Bulker Q&As and CIs on the IACS CSR Knowledge Centre

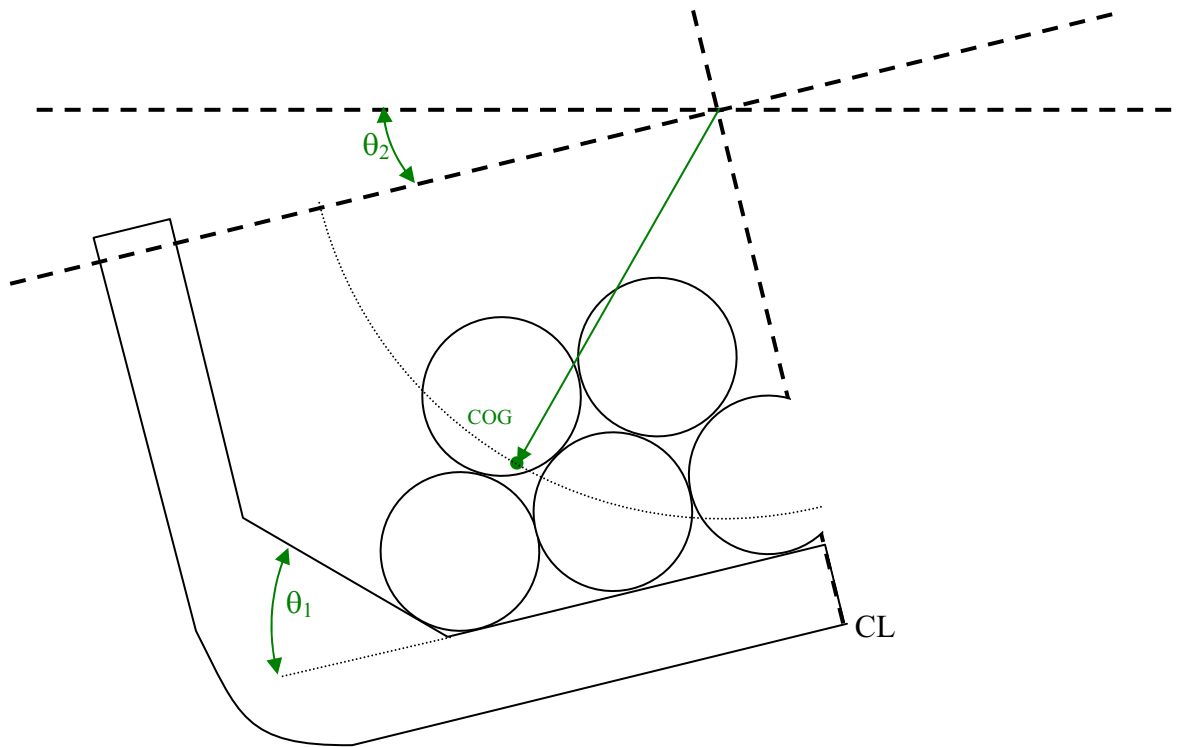
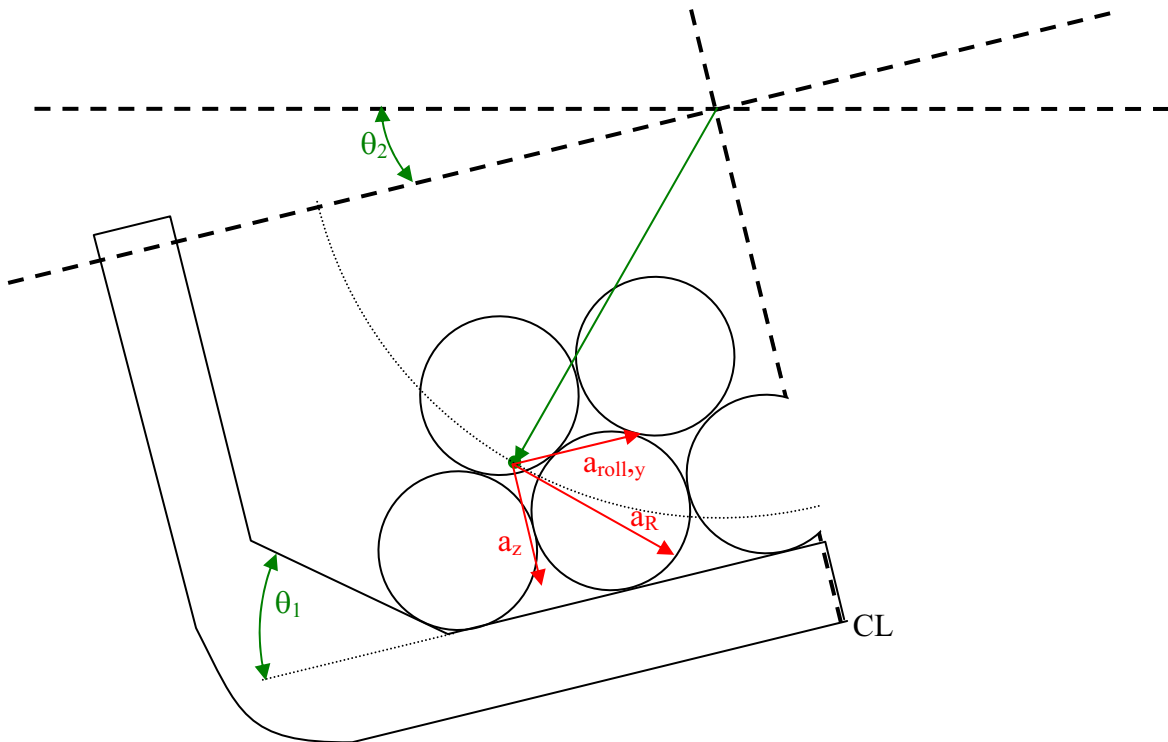
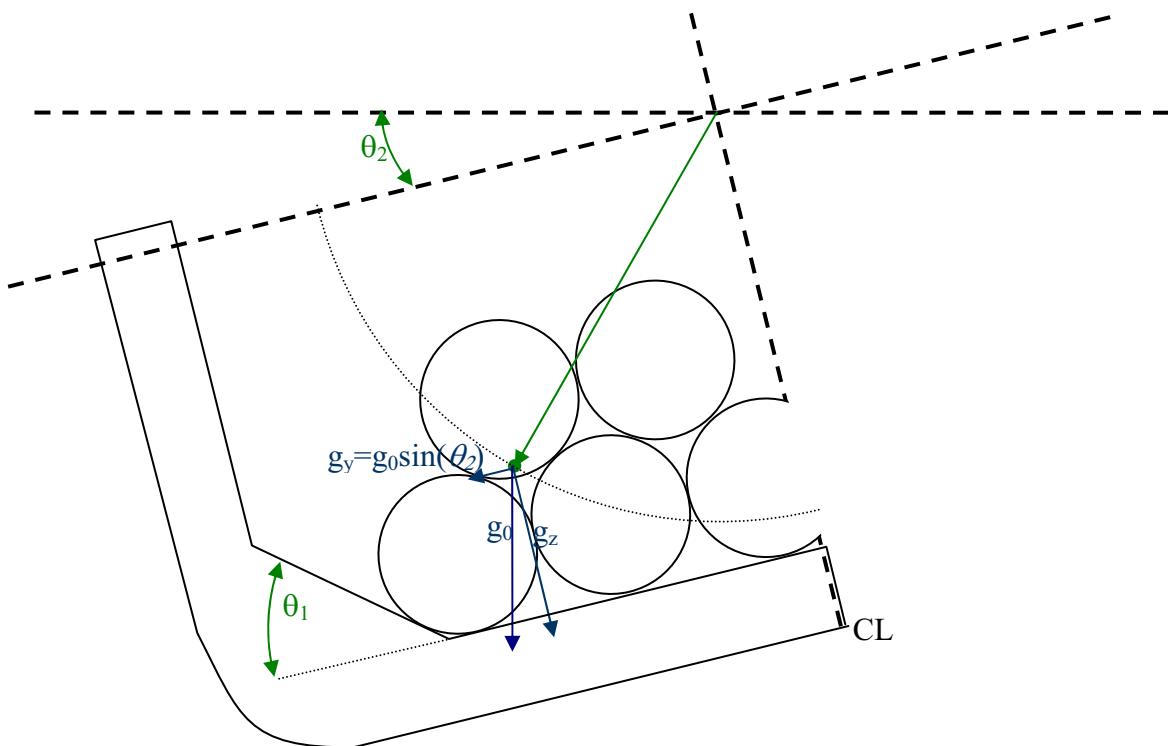
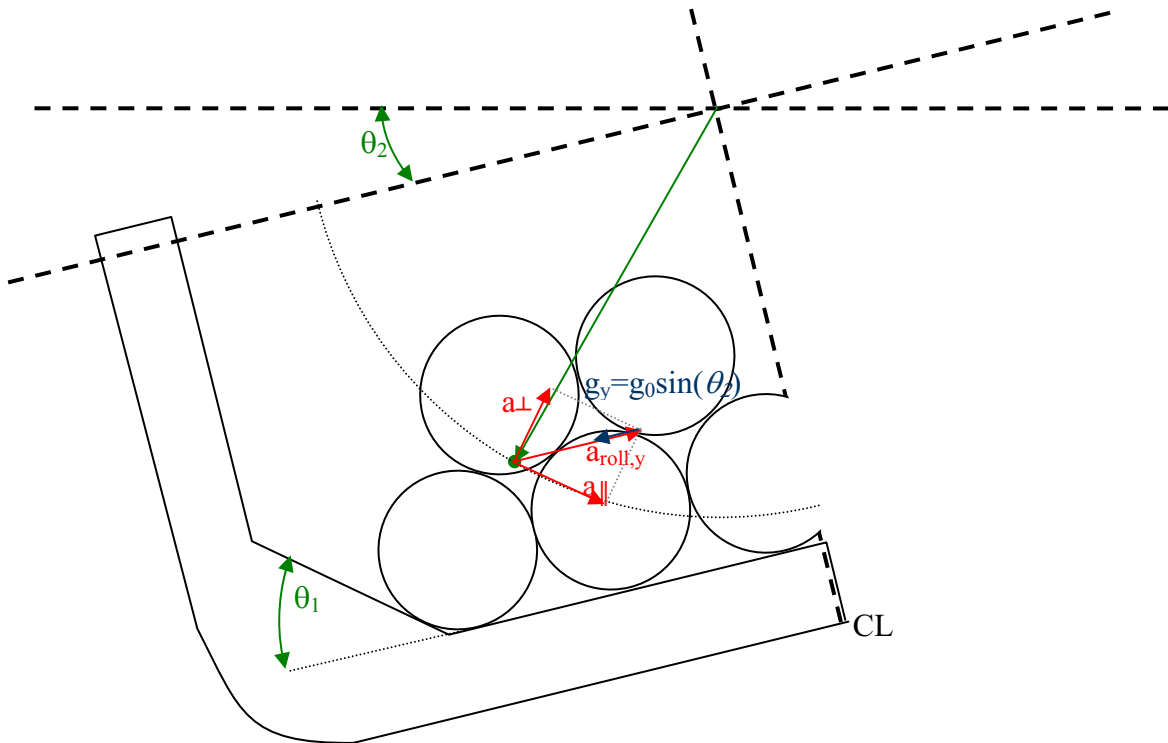
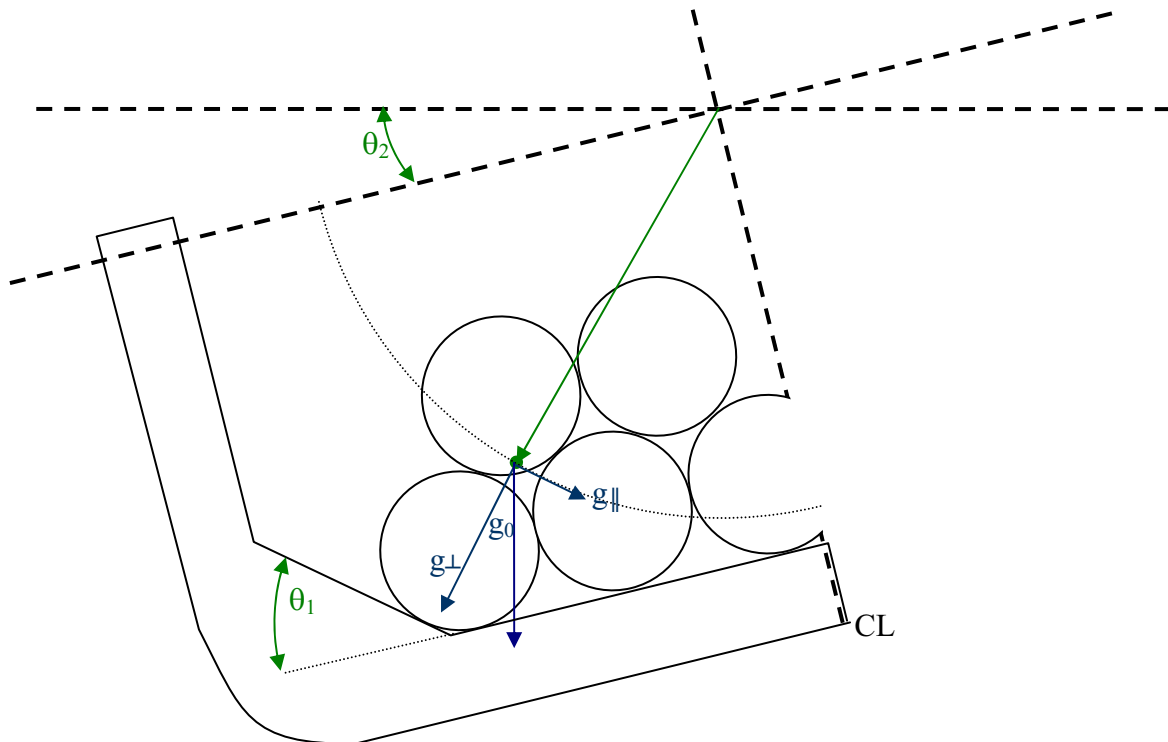
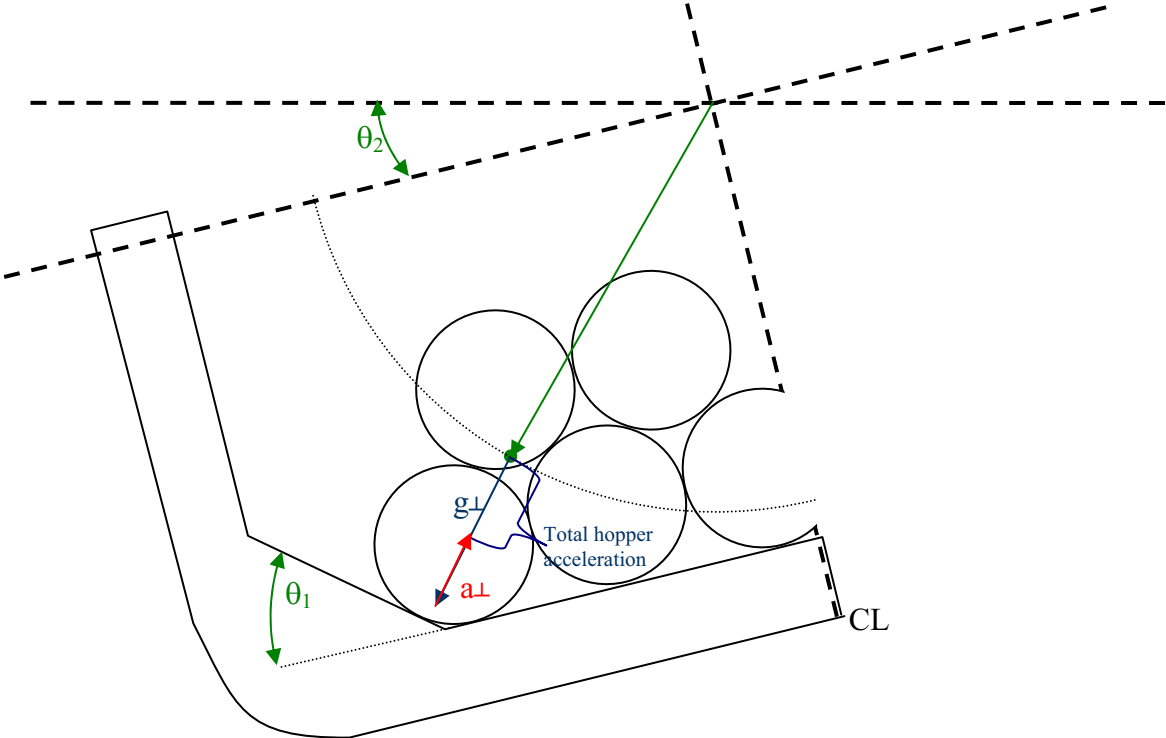
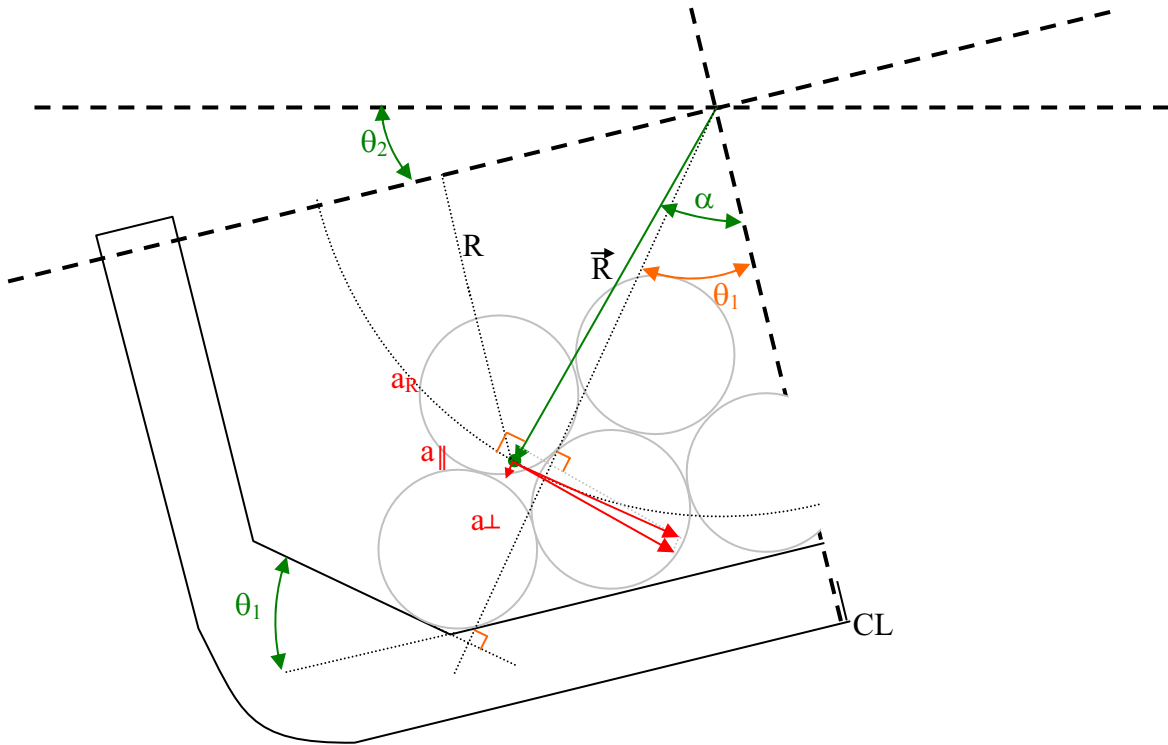
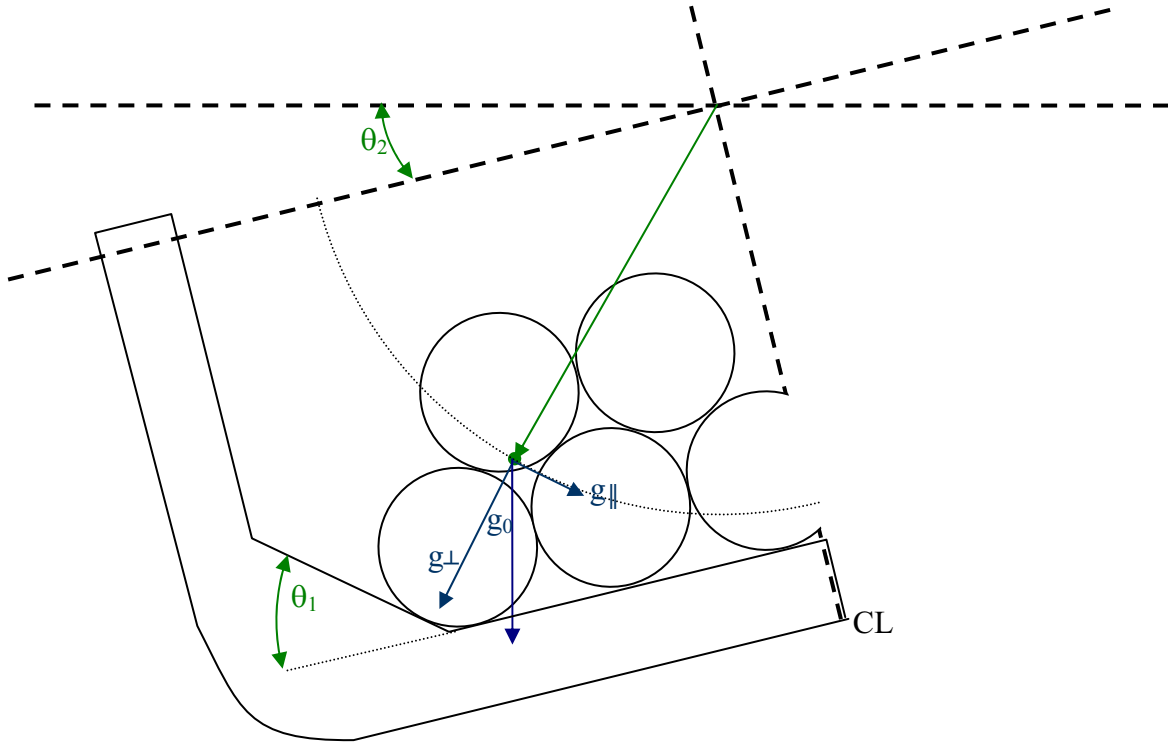
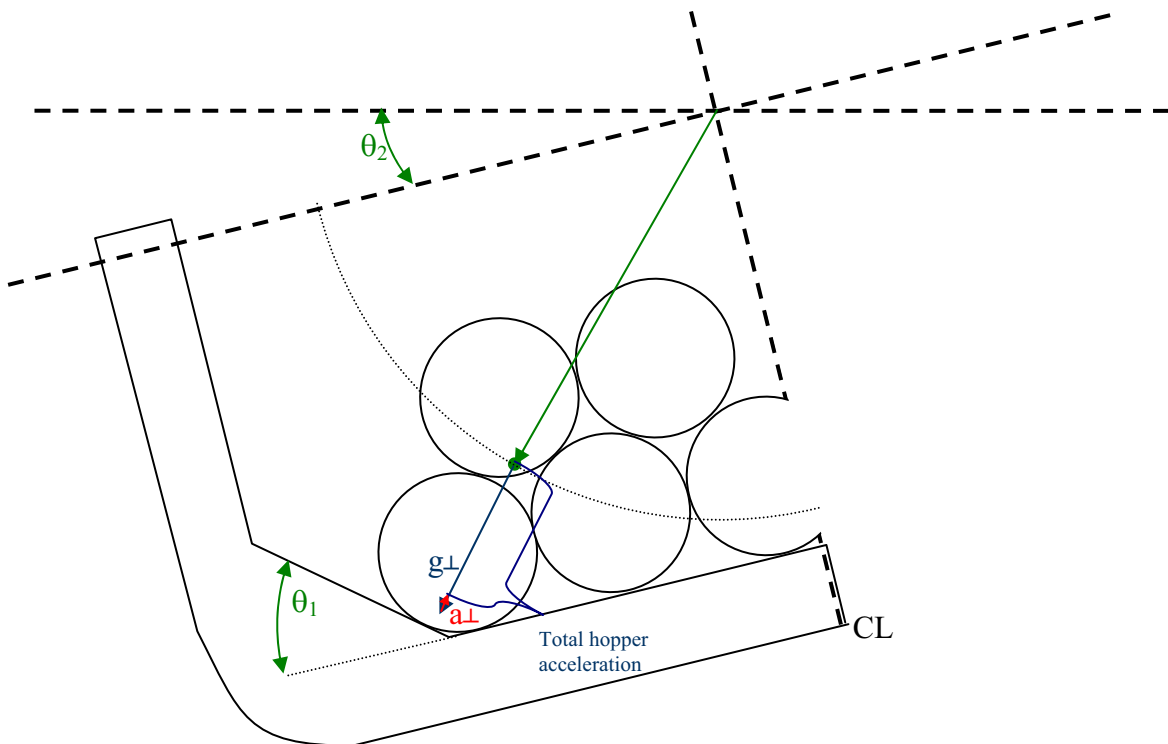
According to Ch. 6 Sec. 1 [2.7.3] Hopper sloping plate and inner hull plating thickness
 The net thickness of plating of longitudinally framed hopper sloping plate and inner hull is to be not less than the value obtained, in mm, from the following formula:

A typical steel coil loading pattern is shown in the figure below. The θ_2 is denoting the roll angle and COG is indicating the centre of gravity of the coils towards the hopper tank. Please see below calculation of the acceleration term in the eq. [2.7.3], $a_{\perp} = g \cos(\theta_1 - \theta_2) + a_y \sin \theta_1$

Please consider below alternative calculation. The calculation is based on the two fundamental acceleration components gravity, g_0 , and roll acceleration a_{roll} .

The coil closest to the hopper is resting on the hopper only. That is, the force on the inner bottom is neglected.

Figure 1: interaction **without** the requirement that the plate has to be stiff enough to withstand each compressive stress alone

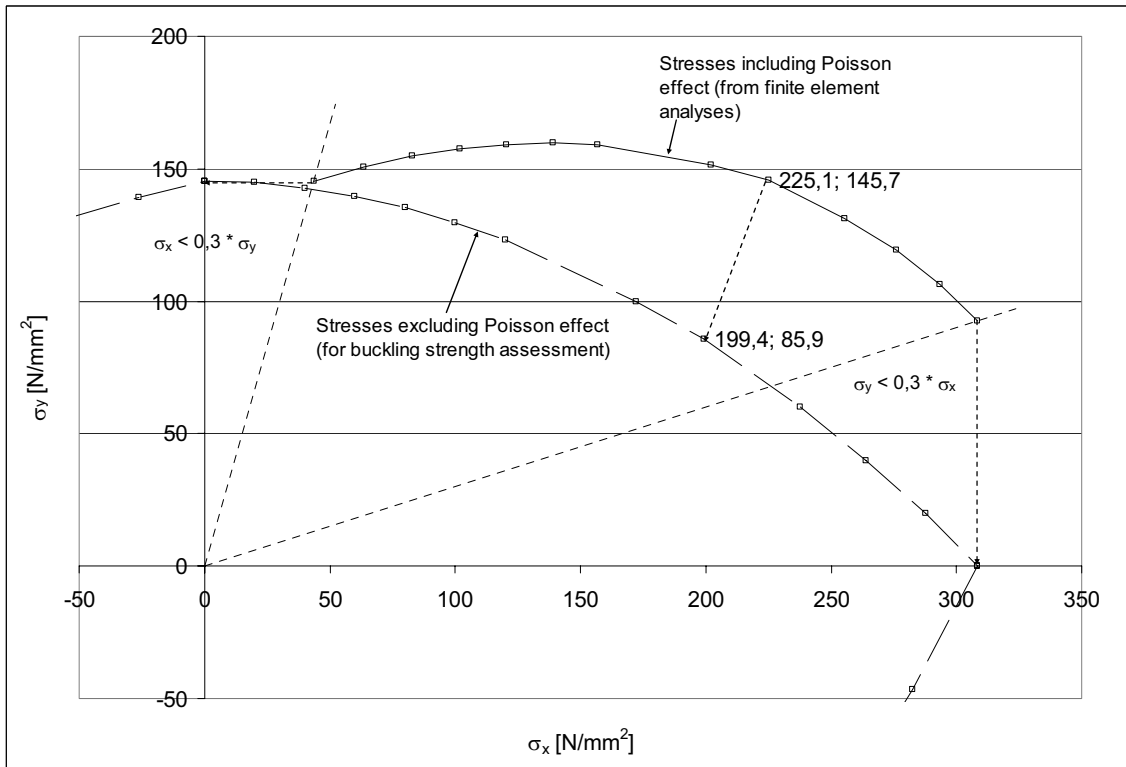
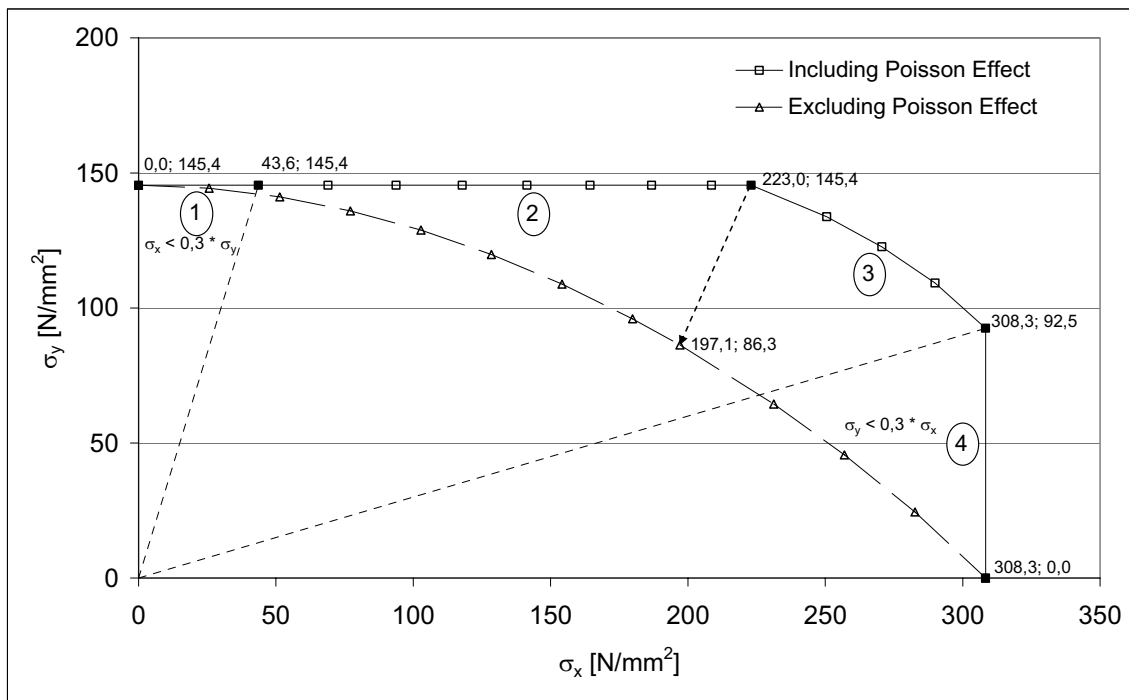
In Figure 1 the interaction curve is shown including the Poisson effect. As can be seen there are stress combinations allowable for which the σ_y -component can be greater, than in the case for σ_y is acting alone on the plate. Because of the problem mentioned above, the interaction curve as the base for the rule requirements is limited to stress combinations as shown in figure 2. Please note that this figure is given in Appendix 1 of the Buckling-TB-document. Please refer to “Buckling Strength Assessment of Plates in the IACS Common Structural rules for Bulk Carriers – Sample Applications” , Figure 2.
